Architectural | Design Statement

Proposed SHD Development
at Dolcain House, Monastery Rd.,
Clondalkin, Dublin 22

January 2022

RESPONSE TO ABP OPINION & SOUTH DUBLIN CITY COUNCIL ISSUES ITEM No.01

1. Pedestrian and Cycle Access

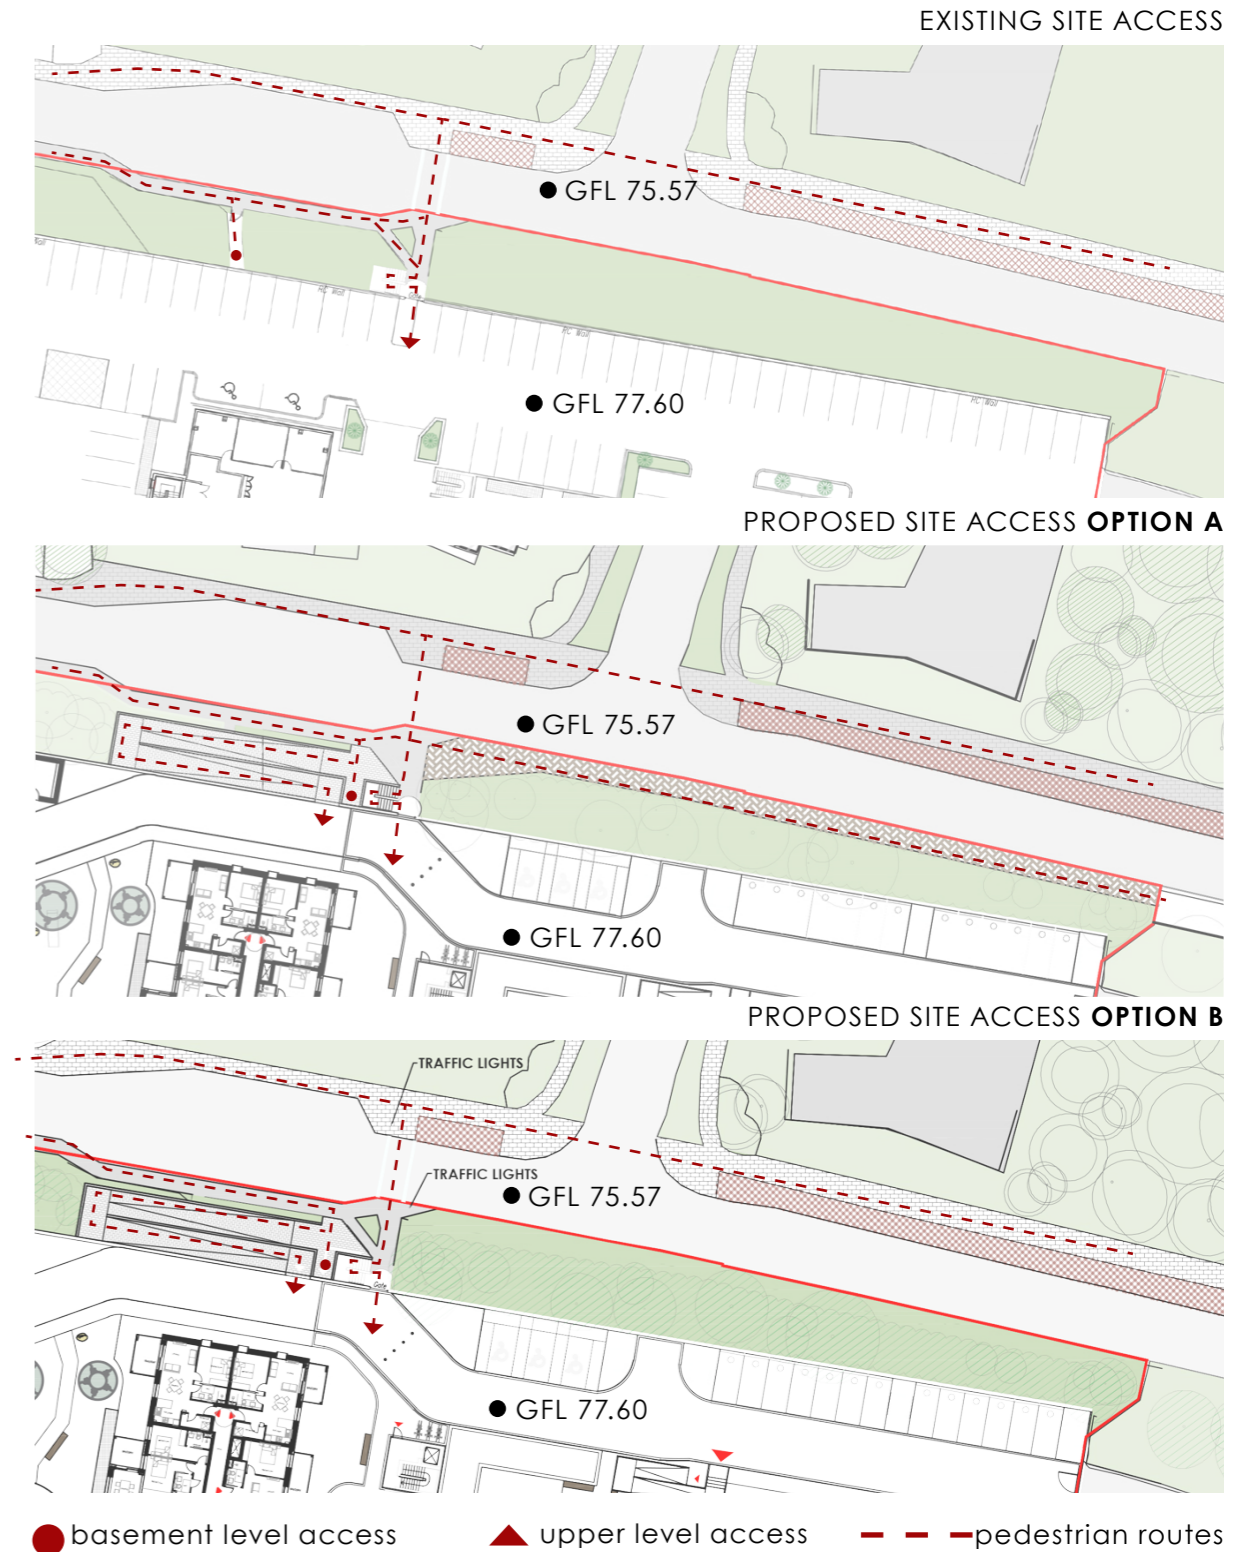
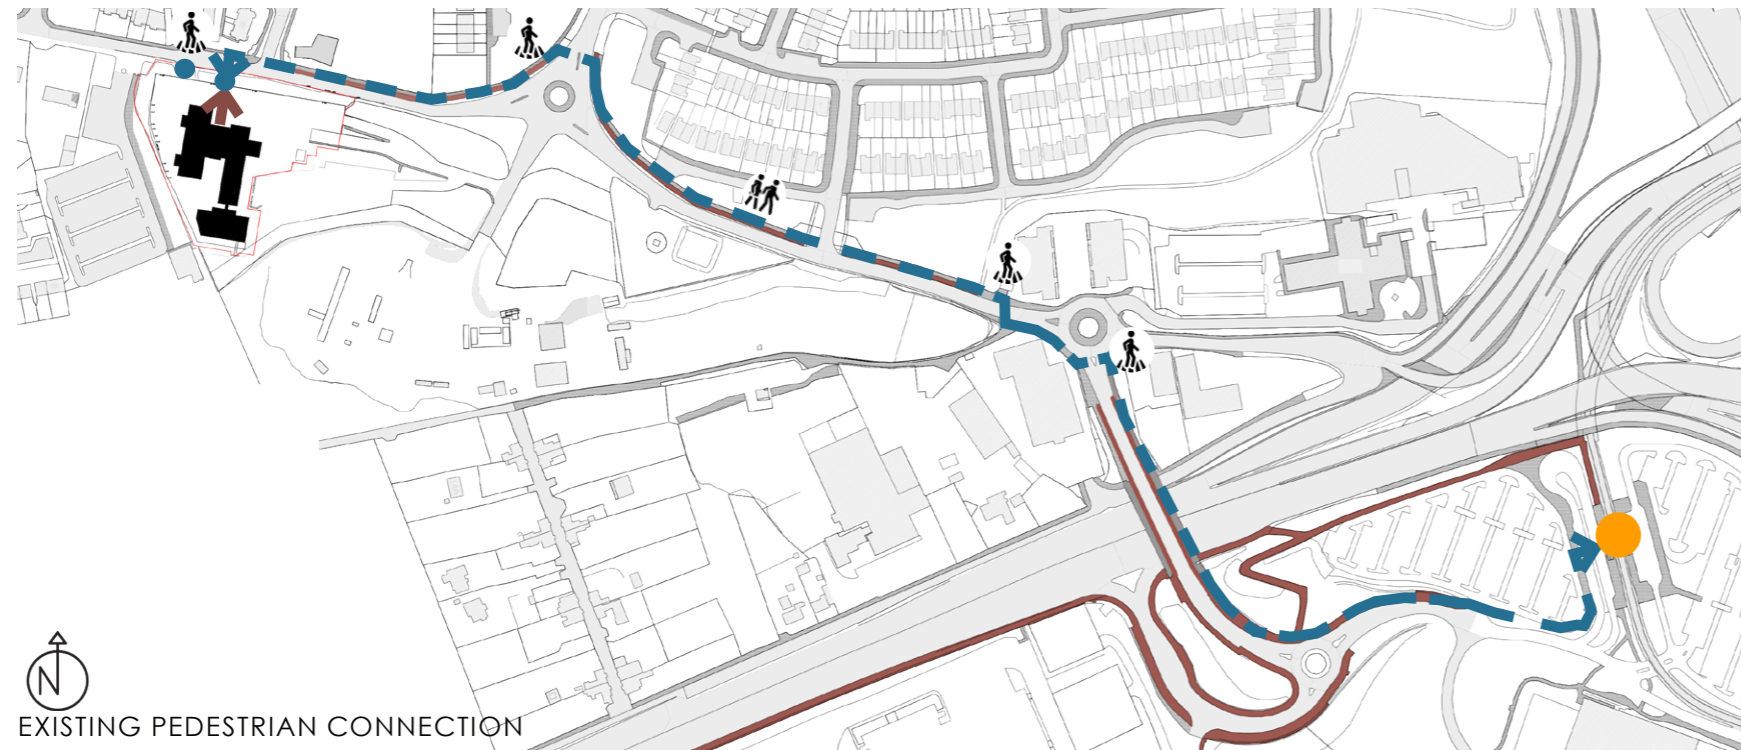
Further consideration of the documents as they relate to pedestrian and cycle access to/from the proposed development is required, in particular how the nature of this access/movement may alter as a result of the change of use from 'employment' to residential use. Consideration should include recognition of desire lines to public transport connections, particularly the Red Cow Luas stop to the east. As part of this, a pedestrian/cycle movement safety audit which would provide details of the scale of pedestrian movement associated with the existing office use, compared to that anticipated with the proposed residential use; along with a description of pedestrian and cycle routes from the site to surrounding areas; as well as any mitigation measures to ensure safe access and egress to the site for pedestrians and cyclists would assist, and demonstrate that these issues have been integrated in to the design of the scheme. Further consideration may require an amendment to the documents and/or design proposals submitted.

The proposed development being submitted to the Board will provide 2 no. options:

- **Option A** will provide for a footpath along the southern side of Monastery Road on the lands within the control of the applicant
- **Option B** will provide for the omission of the footpath at this stage.

Both options will include a new dedicated pedestrian and cyclist entrance ramp to the north of the subject site along Monastery Road which provides access for future residents to the west to Clondalkin and access to the existing pedestrian traffic light crossing which provides access to the east along Monastery Road which comprises footpath and cycle lane to the Red Cow Luas Line. Pedestrian access to the basement will also be provided along Monastery Road and also the access point through the existing stairs will be kept to overcome the difference in level.

As per site layout option A, the applicant will propose a 2m wide footpath on lands within their ownership to the south of Monastery Road, This footpath will also connect into the footpath permitted under Reg. Ref. SD10A/0064.

TABLE 1

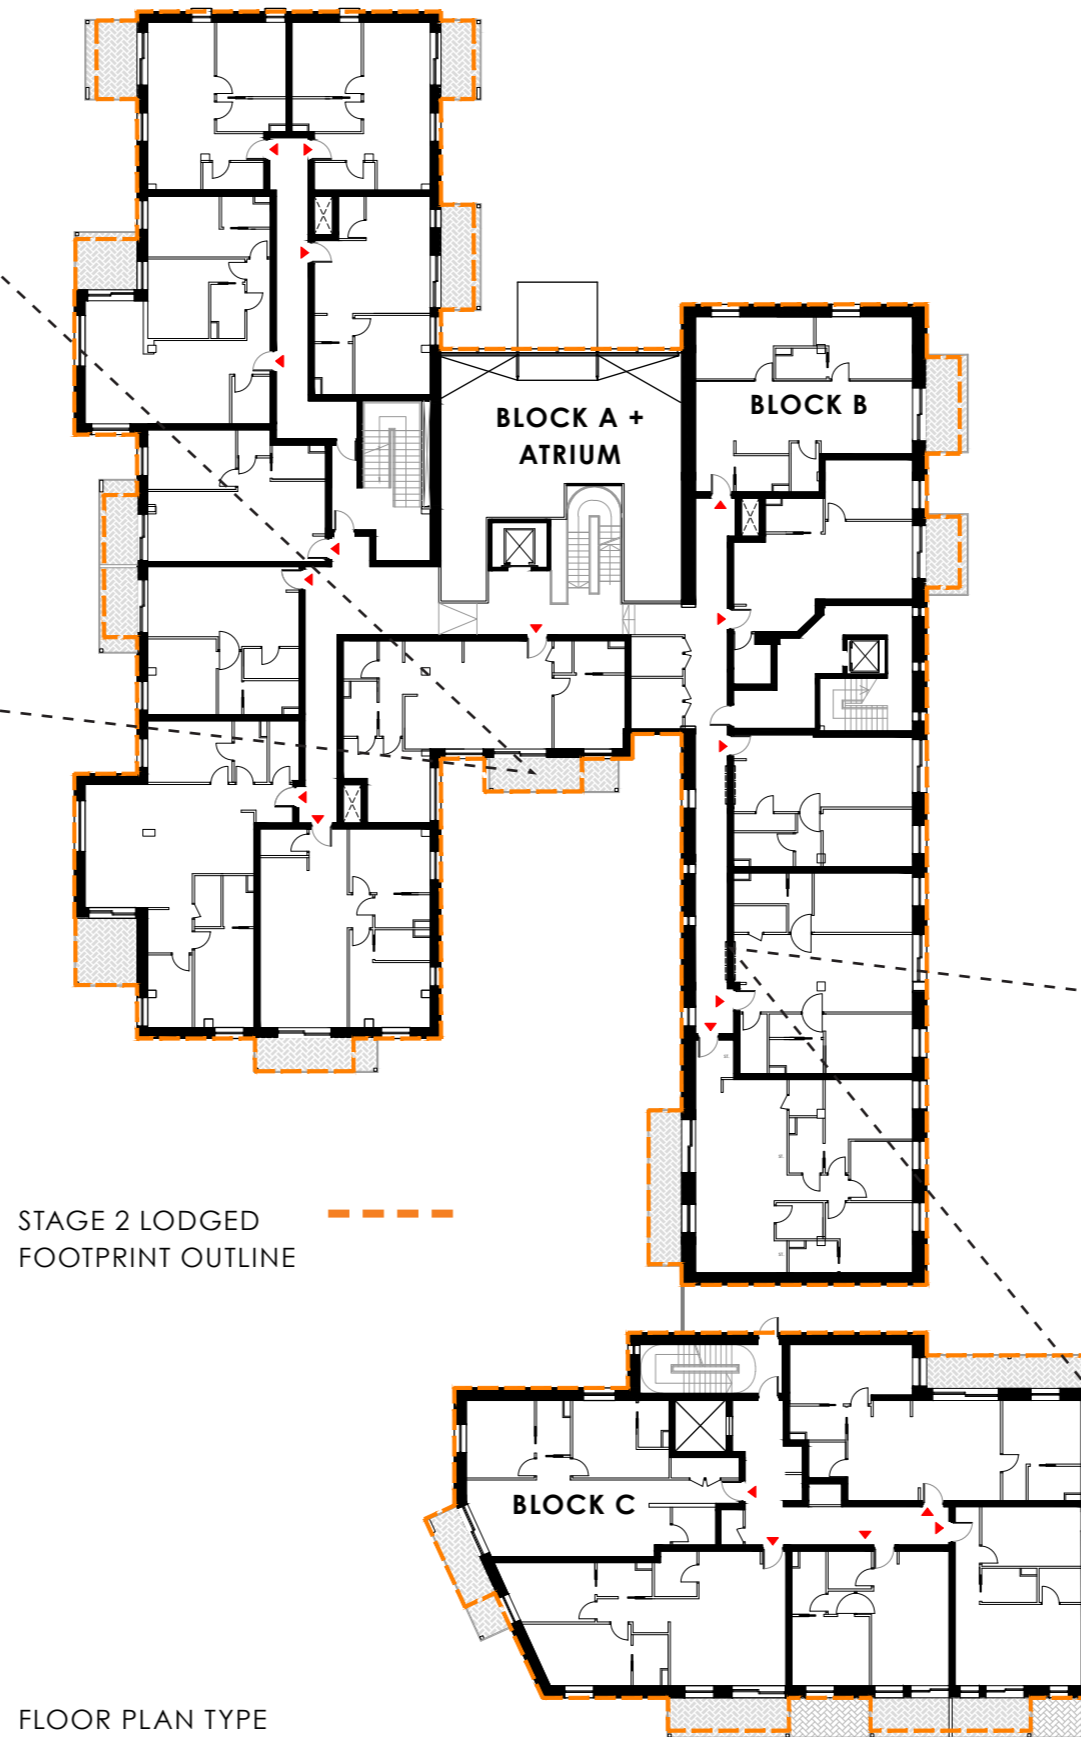
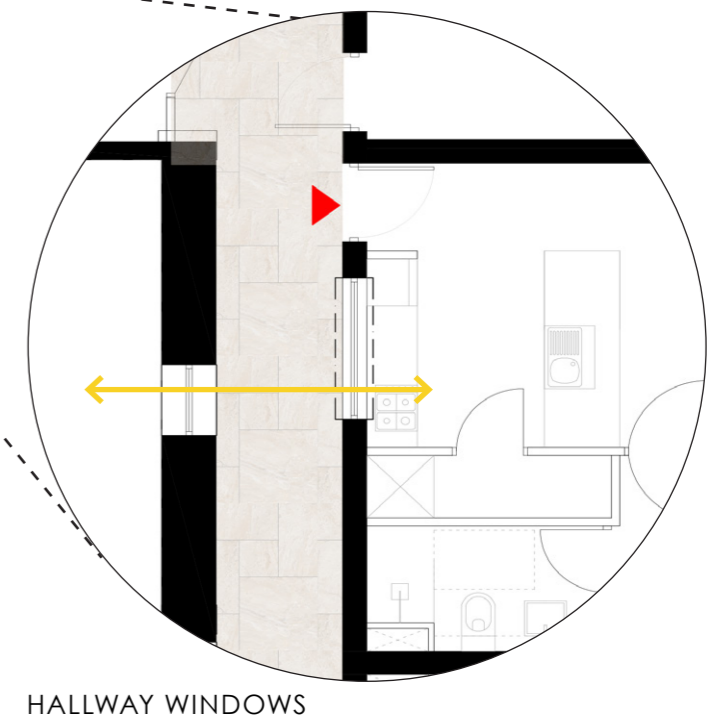
In accordance with the Planning Authority request, most of the private balconies will be increased by 2-4 sqm as per table 1.

UNITS TYPE	DESCRIPTION	PRIVATE SPACE REQUIRED	PRIVATE SPACE PROVIDED
TYPE A	1 BED	5 sqm	9 sqm
TYPE B	2 BEDS	7 sqm	8 sqm
TYPE C	1 BED	5 sqm	9 sqm
TYPE D	1 BED	5 sqm	7 sqm
TYPE E	2 BED	7 sqm	9 sqm
TYPE F	1 BED	5 sqm	7 sqm
TYPE G	2 BED	7 sqm	9 sqm
TYPE H	2 BED	7 sqm	9 sqm
TYPE H	2 BED	7 sqm	9 sqm
TYPE J	1 BED	5 sqm	7 sqm
TYPE K	2 BED	7 sqm	9 sqm
TYPE L	1 BED	5 sqm	10 sqm
TYPE M	1 BED	5 sqm	14 sqm
TYPE N	1 BED	5 sqm	12 sqm
TYPE O	1 BED	5 sqm	9 sqm
TYPE P	1 BED	5 sqm	6 sqm
TYPE Q	2 BED	6 sqm	7 sqm
TYPE R	3 BED	9 sqm	11 sqm
TYPE S	2 BED	7 sqm	9 sqm
TYPE T	2 BED	7 sqm	10 sqm
TYPE U	1 BED	5 sqm	7 sqm
TYPE V	1 BED	5 sqm	7 sqm
TYPE W	2 BED	7 sqm	12 sqm
TYPE X	2 BED	7 sqm	9 sqm
TYPE Y	1 BED	5 sqm	9 sqm
TYPE Y	1 BED	5 sqm	9 sqm

The graphic beside is showing how the increased balcony ensures the creation of more habitable and spacious private amenities.

Also, some of the units located on block B will be provided with internal windows facing the gallery on the western elevation. This will increase the quantity of light in the main living area.

BASEMENT FLOOR PLAN-STAGE 2

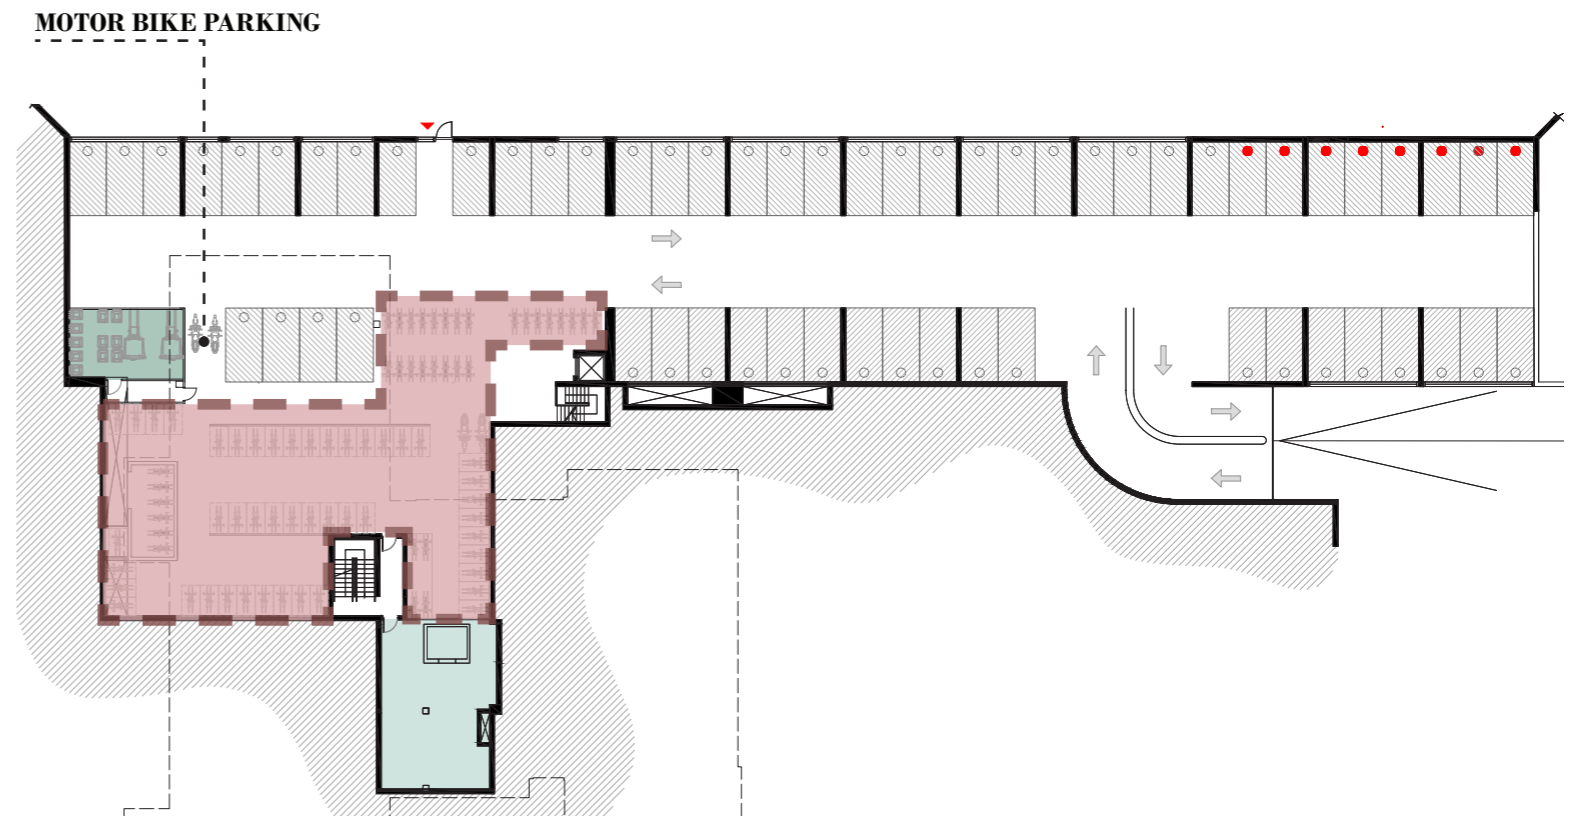
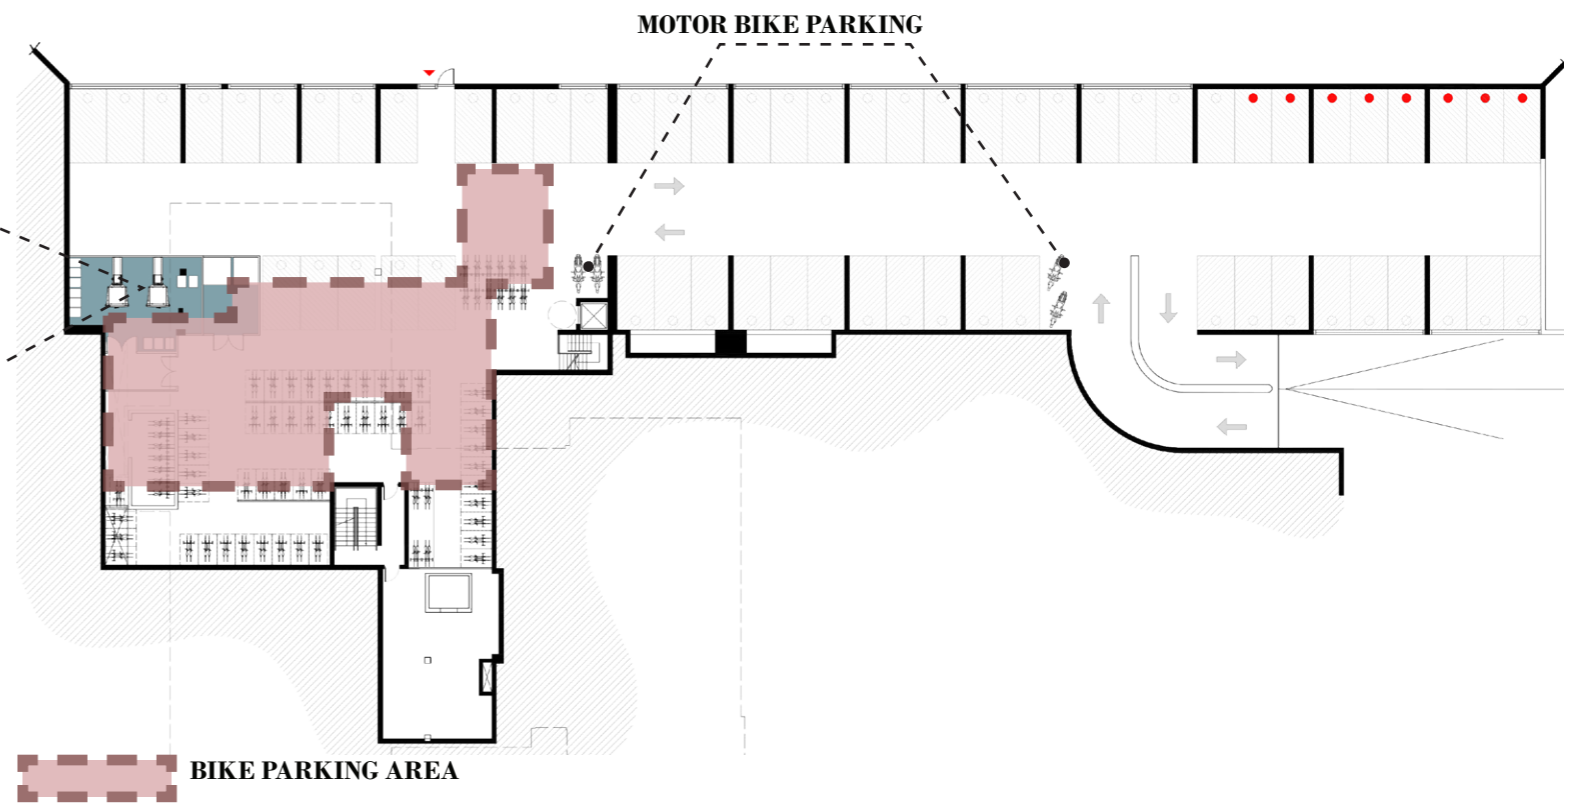
A new layout for bicycle and car parking, at the basement level, will be proposed, due to the increased bins storage area.

An Operational Waste Management plan prepared by Awn Consulting will demonstrate the waste strategy proposed, appropriate storage areas together with a high level of recycling, reuse and recovery will be incorporated into the design of the development.
